Architect's Supplemental Instructions

Architect's ASI No: 063

Project:
Webster University
Interdisciplinary Science
Building

Date Issued: 04/21/17

A0701.B

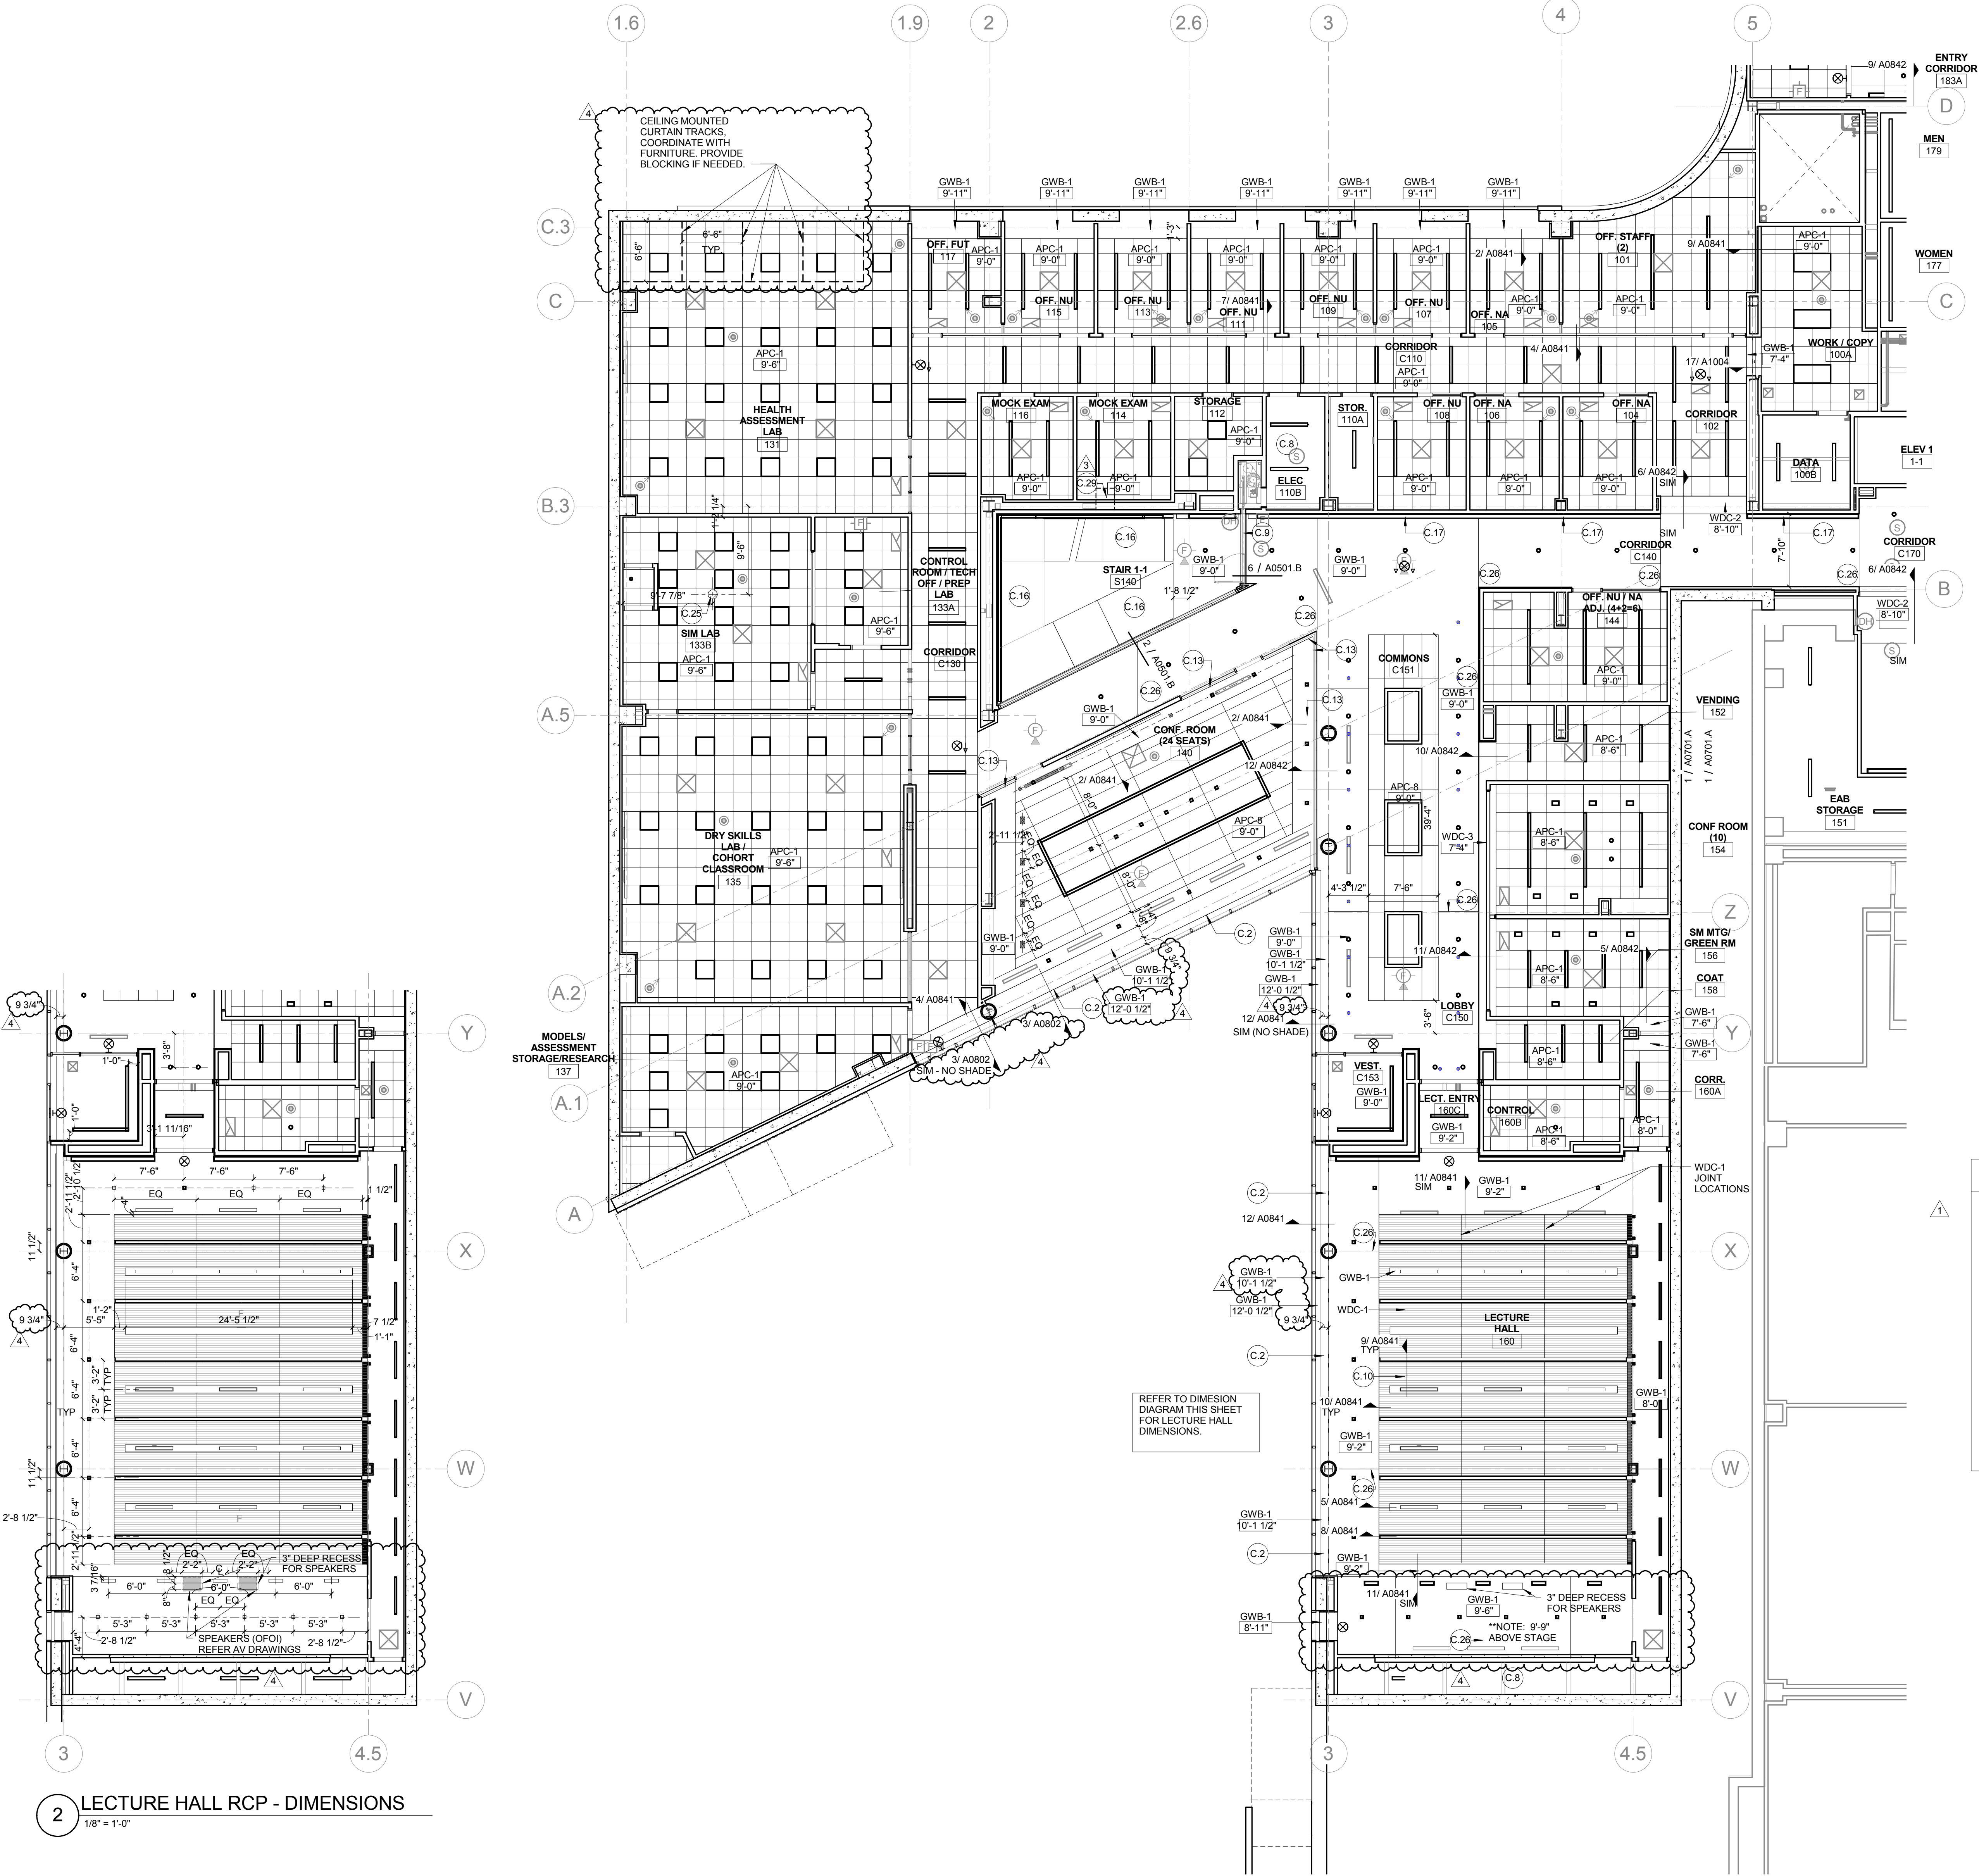
- Revised partition layout and details to accommodate revised Video wall selection per AV drawings.
- Added ceiling mounted curtain tracks in room 131 HEALTH ASSESSMENT LAB.

E0101.B

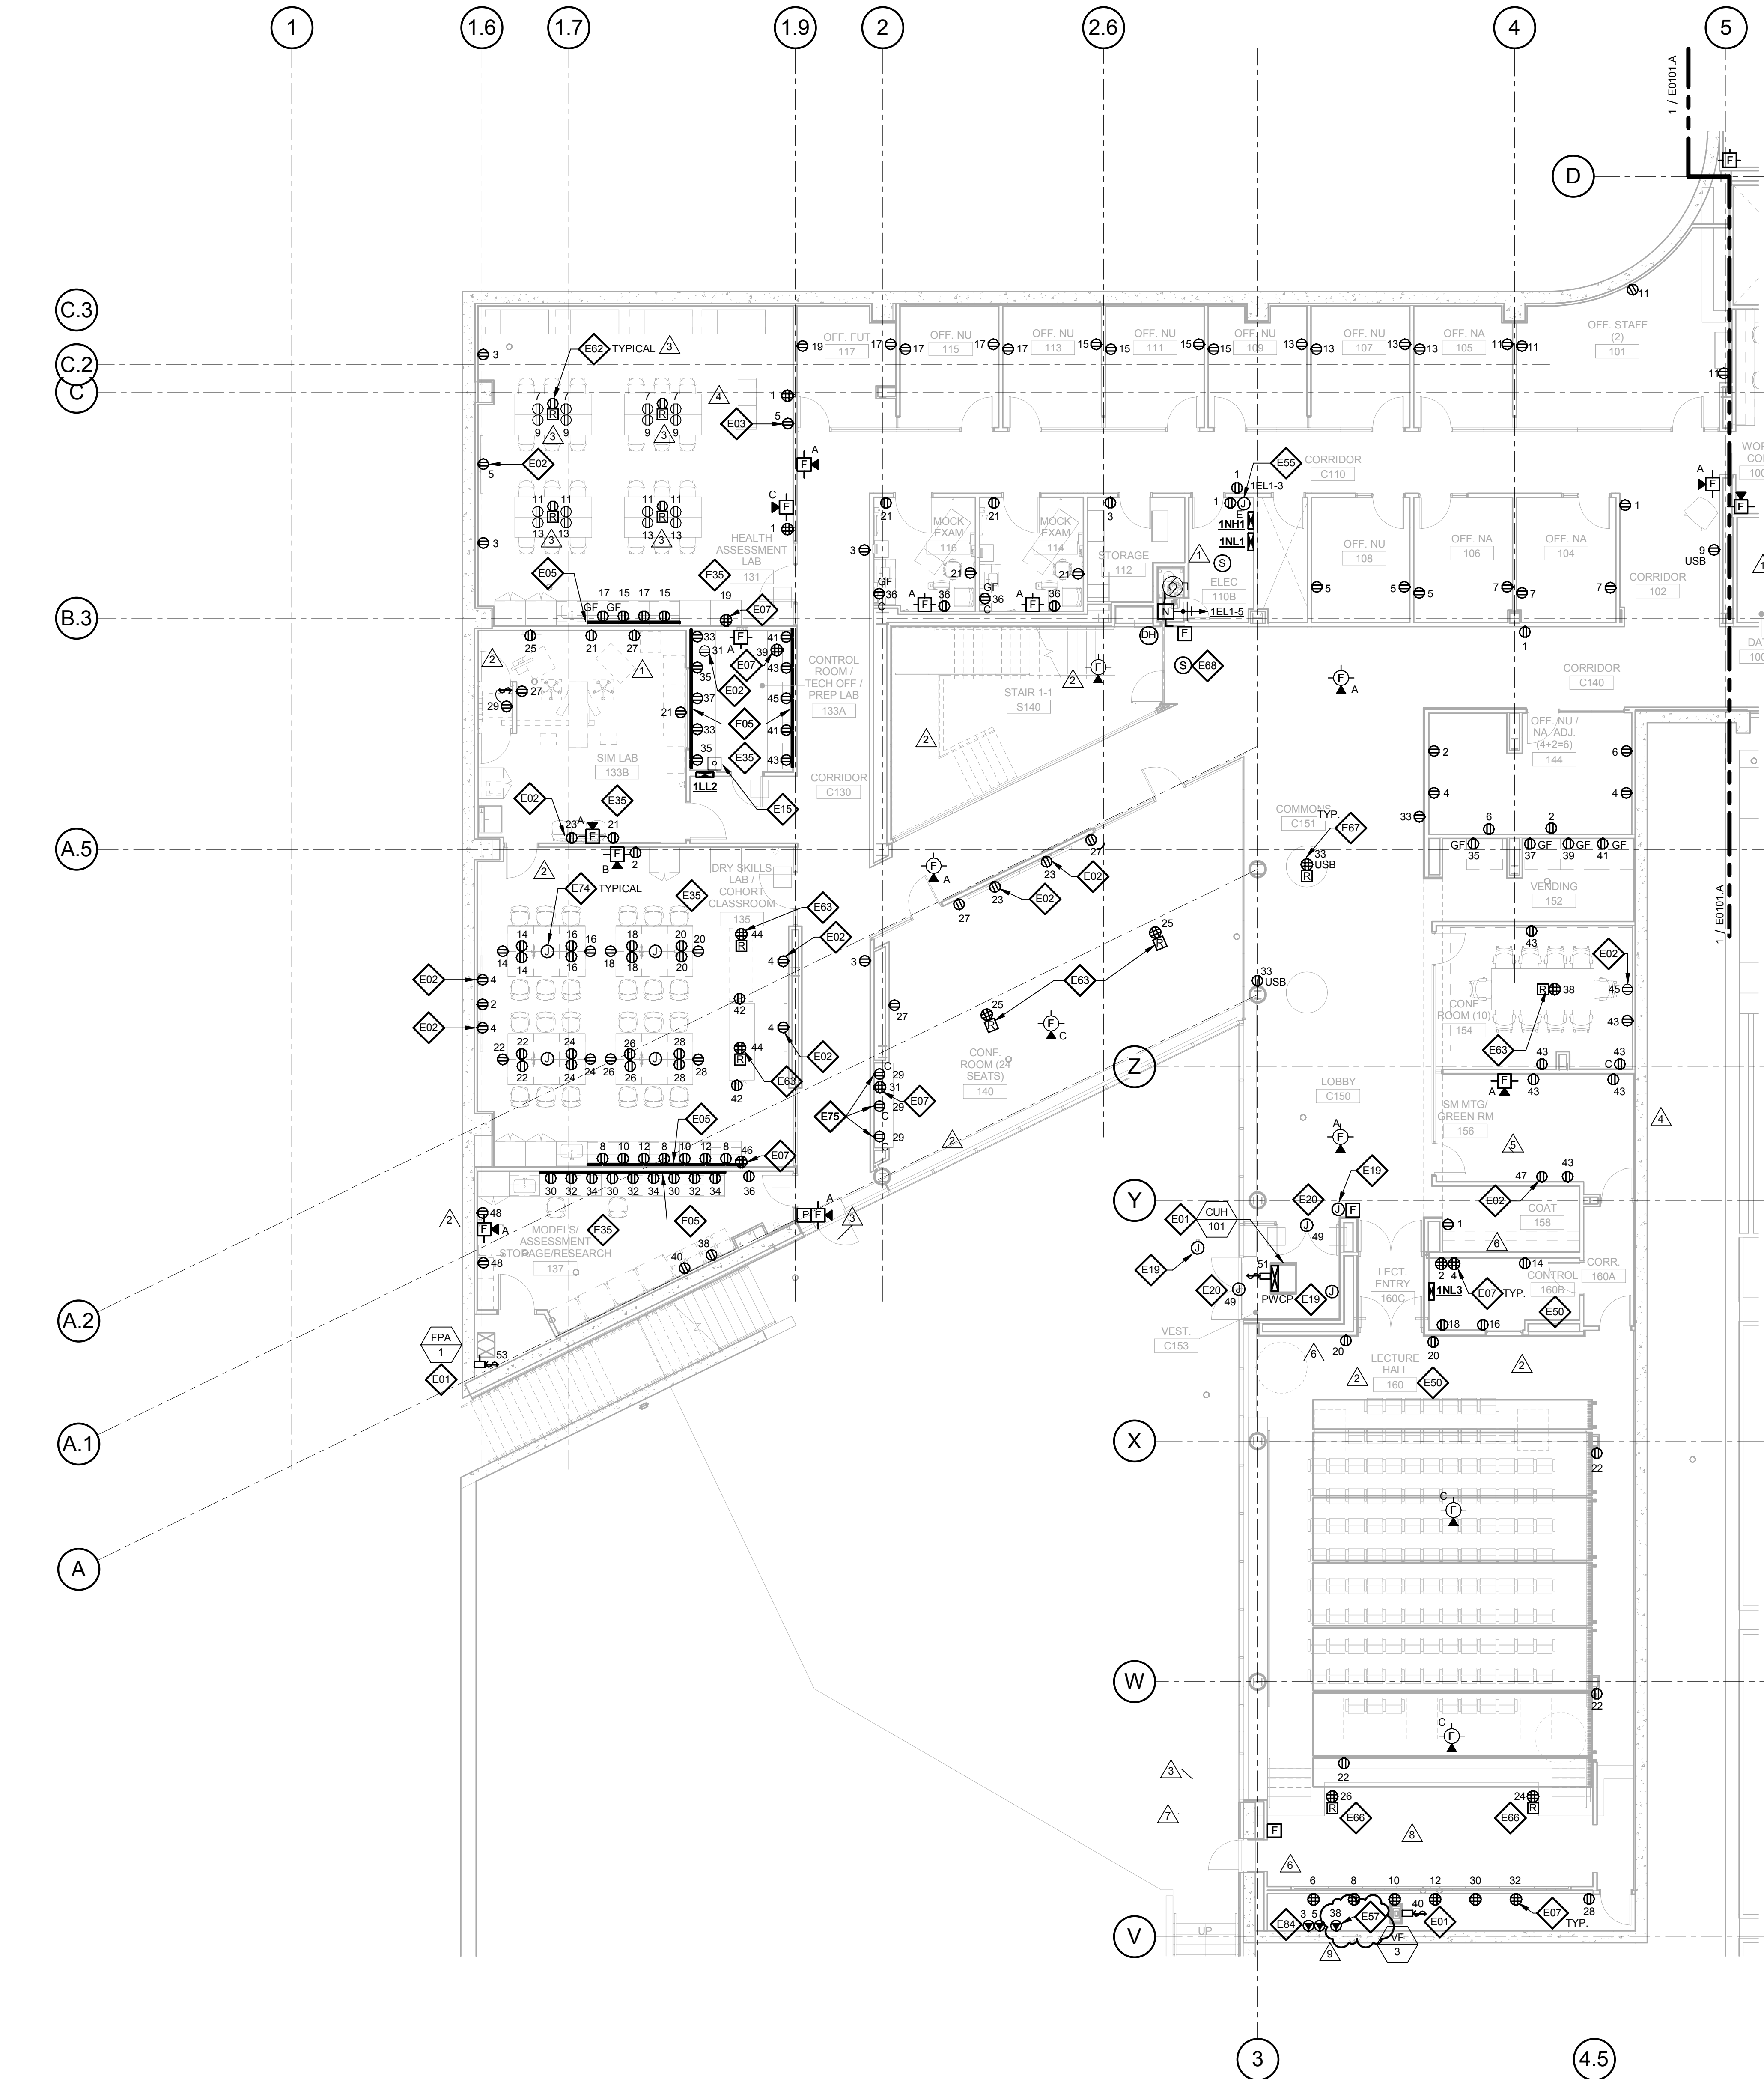
- Move power serving subwoofer to wall. Provide Nema L5-20R twist-lock receptacle in lieu of junction box. See keyed note E57.

- E57 PROVIDE NEMA L5-20R TWIST-LOCK RECEPTACLE FOR SUBWOOFER, COORDINATE LOCATION WITH A/V DRAWINGS.
- E62 PROVIDE A 2HR FIRE CLASSIFIED 2-GANG MULTI-SERVICE STEEL RECESSED FLOOR BOX EQUAL TO WIREMOLD CAT. NO. RFB2S-FC WITH A BRASS FLANGED COVER CAT. NO. FFBTCS-NA. THE FLOOR BOX SHALL HAVE ALL NECESSARY MOUNTING BRACKETS FOR (2) 20A DUPLEX RECEPTACLE, (1) GANG - DATA/VOICE (SEE TECHNOLOGY DRAWINGS FOR DEVICE TYPE), (1) GANG - A/V (SEE A/V DRAWINGS FOR DEVICE TYPES). THE BOX SHALL BE INSTALLED PER MANUFACTURERS WRITTEN INSTRUCTIONS SO THAT THE COVER IS FLUSH WITH THE FLOOR.

E0103.B

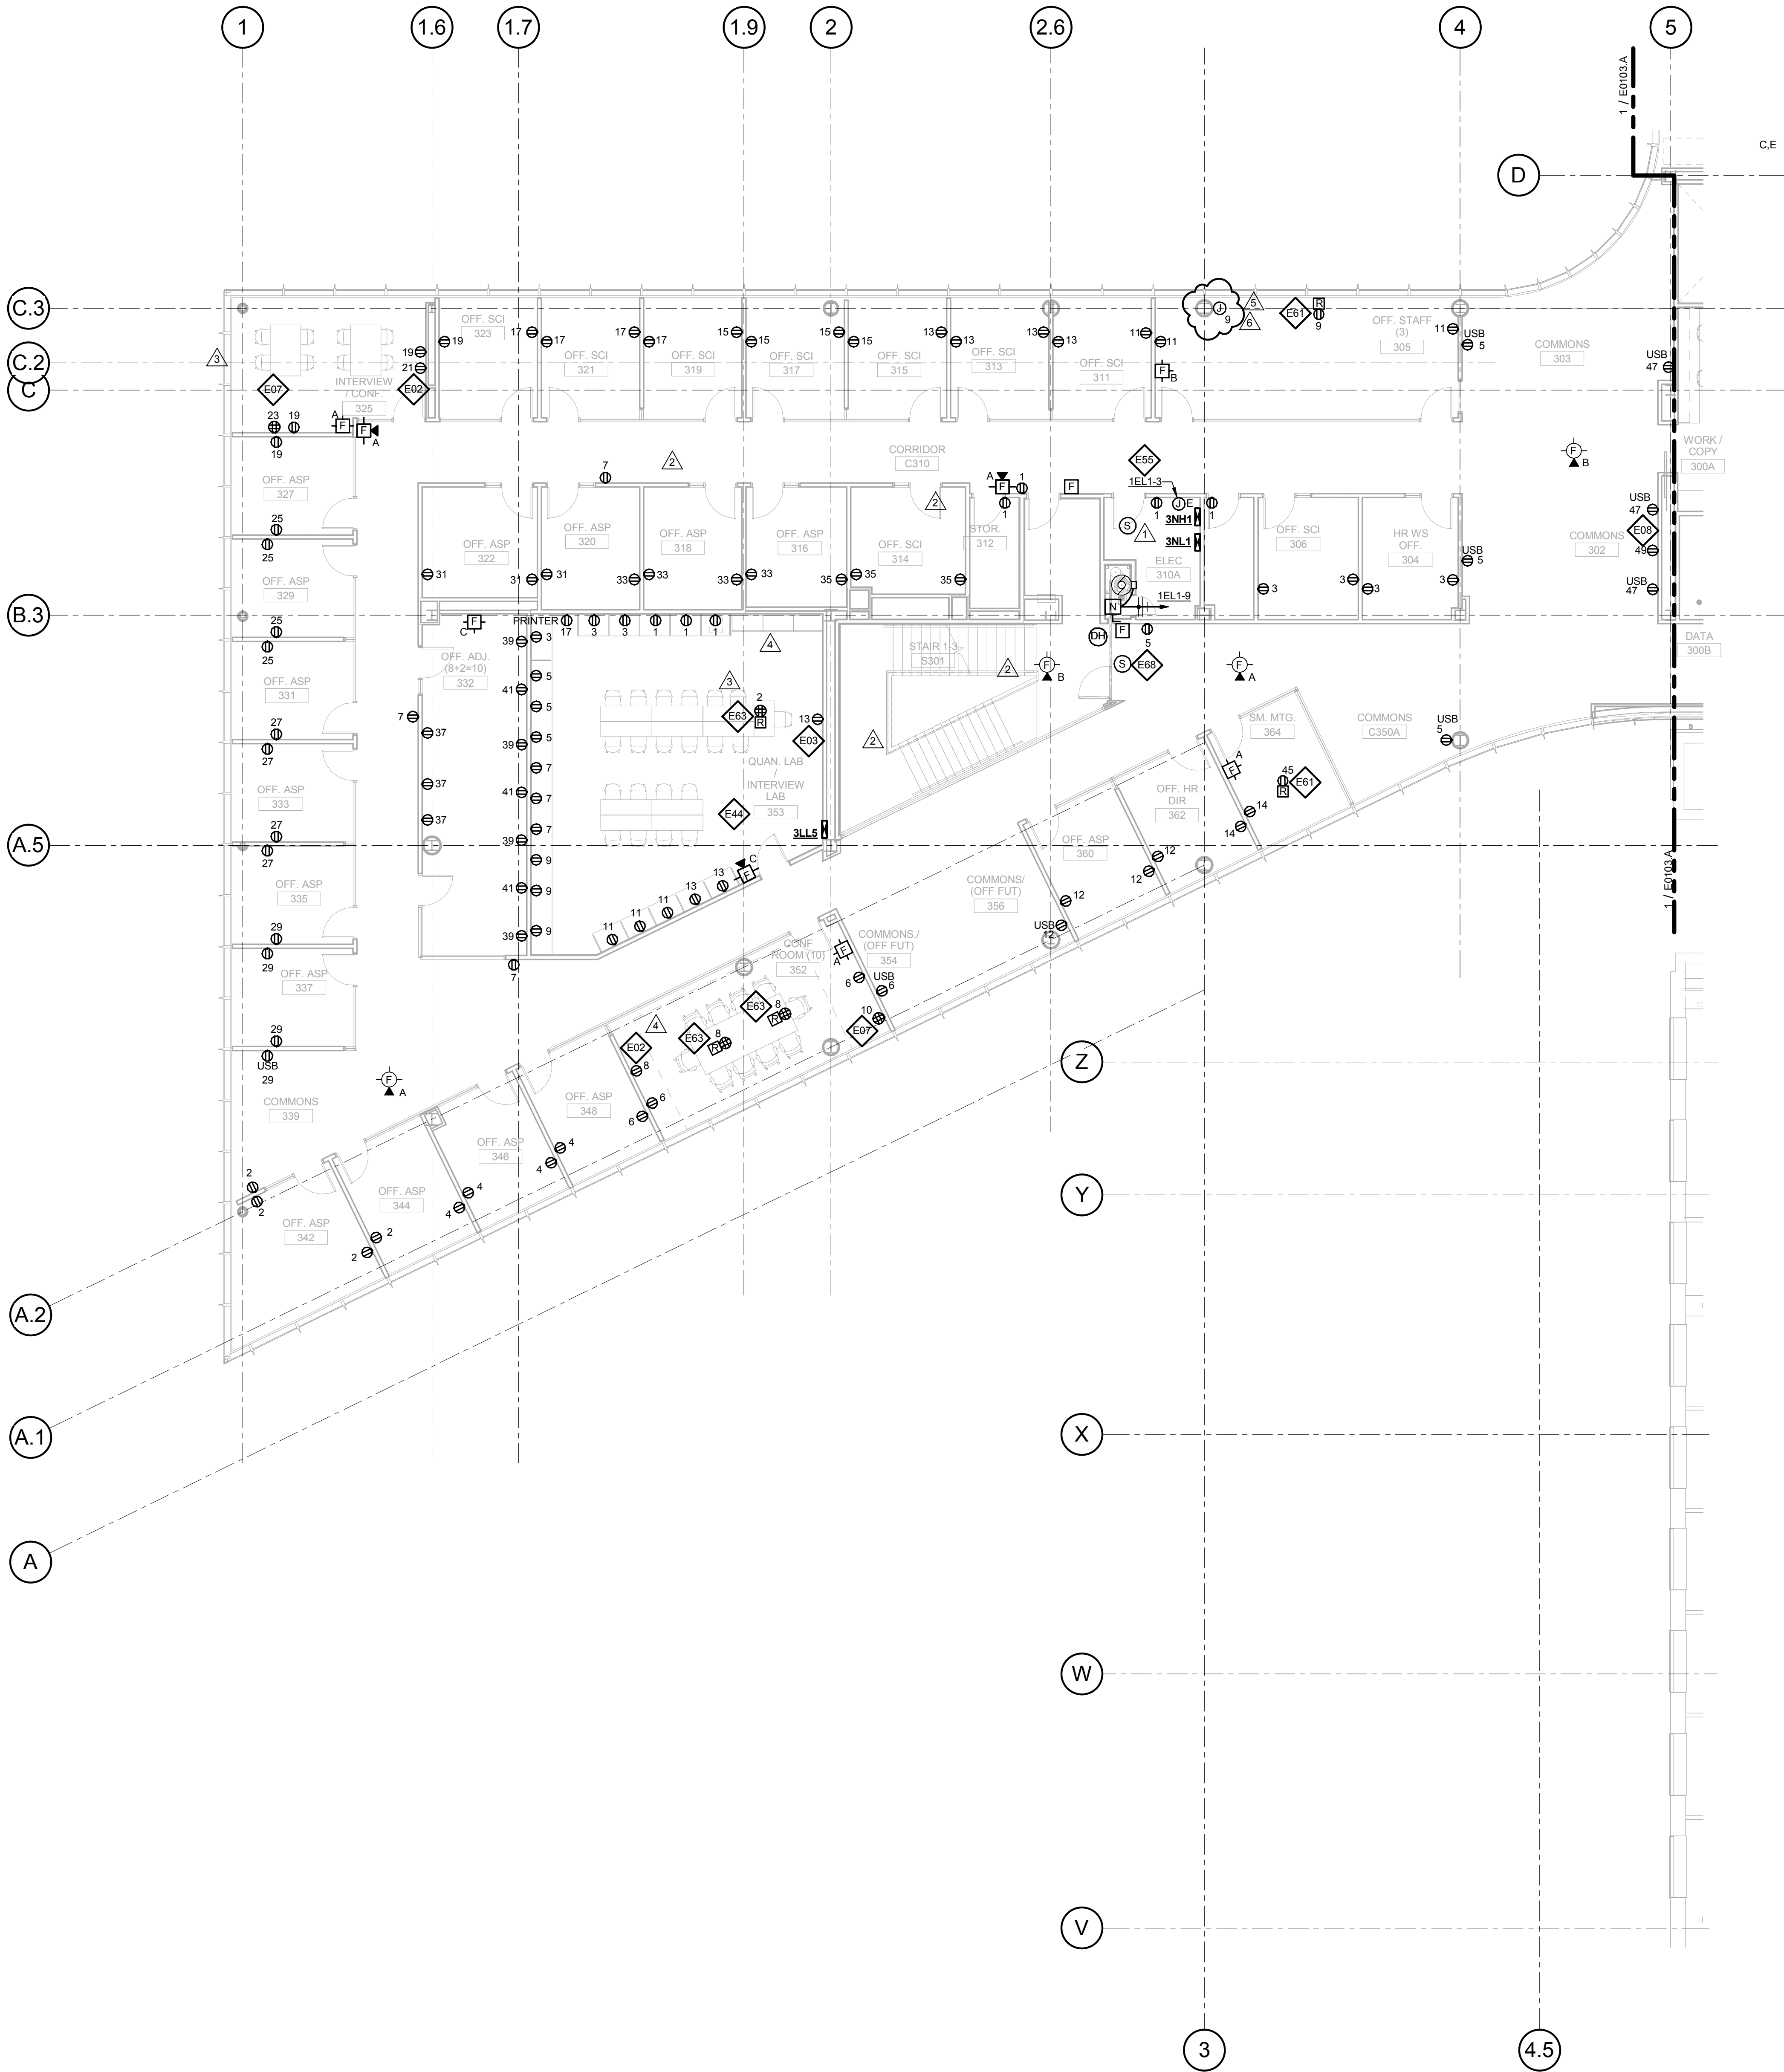
- At column C.3, 3 - Provide j-box in lieu of receptacle for power to furniture.
